PRODUCT CHANGE NOTIFICATION

Product Identification: 0826 1x1 ICM Product Family

PCN Number: PC2160135

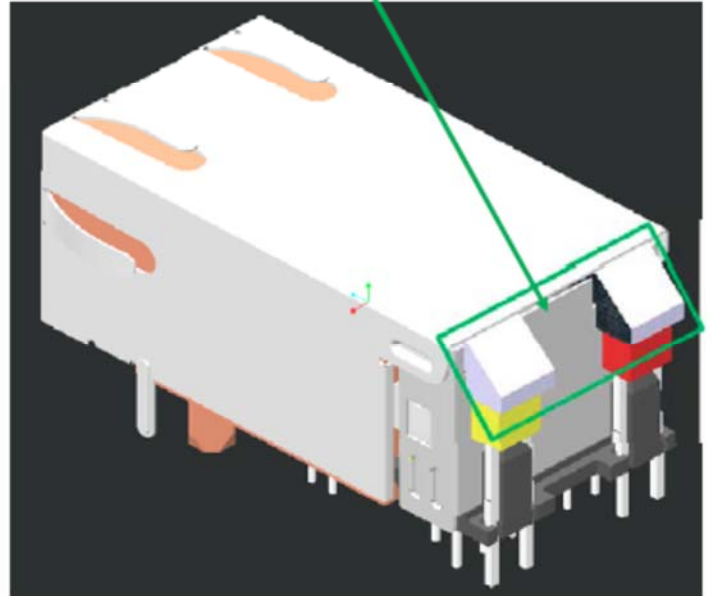
Reason for Change (s): In an effort to continually improve our product, Bel is pleased to announce a simple update to the light-pipe of the ICM. In an effort to improve the light transmission properties of the ICM and prevent unwanted color bleed over from one side to the other, the rear bridge of the light-pipe is being removed. There is still a middle bridge to hold the 2 halves together and the internals of the plastic housing still support the light-pipe as it always did. These changes will not affect “form, fit, or function”, nor do they affect any other dimensions or electrical parameters of the part. No other changes to the above series are being implemented at this time.

Description of the Change (s): Bel is updating the light-pipe design per the description below.

Remove the rear bridge of the exposed LP.
